**COMMENTS ON PROPOSED REACTOR SITE CRITERIA**

The following comments on the reactor site criteria, Staff Paper AEC-R 2/19, are based on NRTS operational experience and field studies on uncontained research and test reactors.

SCALE   
STACK HEIGHT - 520 FEET  
ANNUAL MEAN - NEGATIVE CONCENTRATION (%V)  
POTENTIAL ZONES OF CONTAMINATION

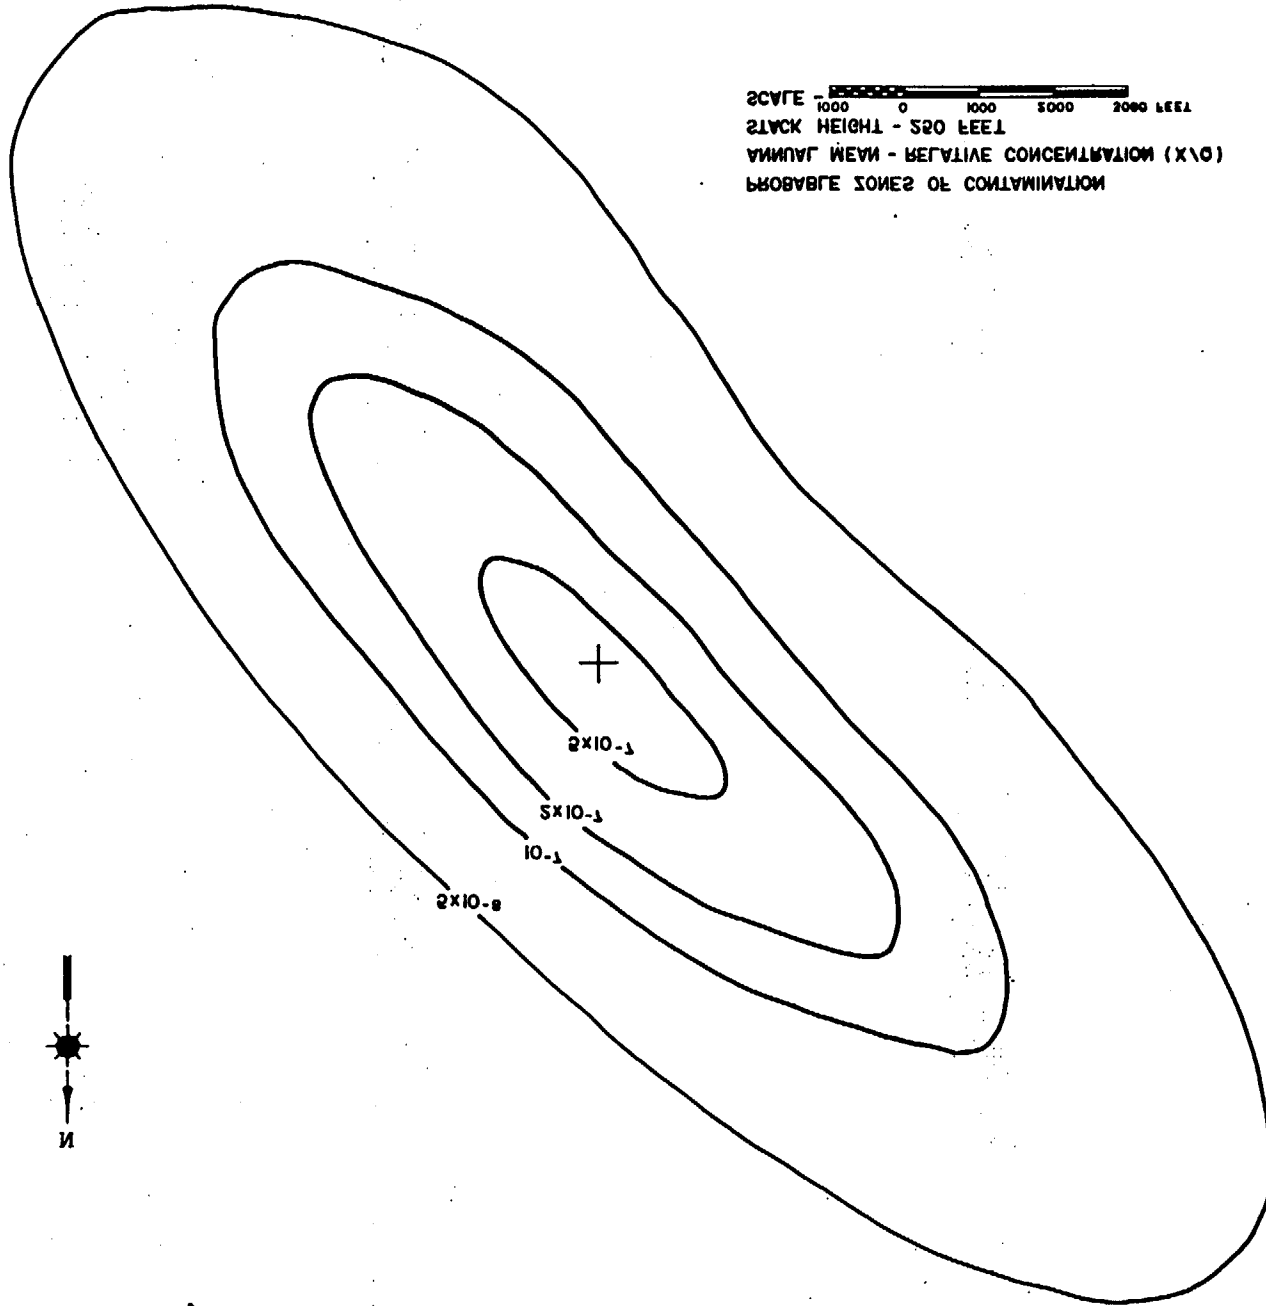
Circular exclusion and evacuation areas of certain radii can be questioned based upon observed and computed air concentration and deposition patterns. This is particularly true for regions where winds usually blow along certain directions, such as valley-mountain winds confined along the valley axis, or channelled winds along river valleys. This is even more striking if winds of one direction are associated primarily with temperature lapse conditions, and winds of the opposite direction are associated with inversions. Long period integrated air concentration or deposition isopleths, as well as computed mean diffusion isopleths of relative concentration, are more elliptically shaped along the prevailing wind direction. Therefore, elliptically shaped exclusion or evacuation areas are preferable to circular areas. Enclosed is a sample isopleth for the southern part of the BRTR to demonstrate this approach.
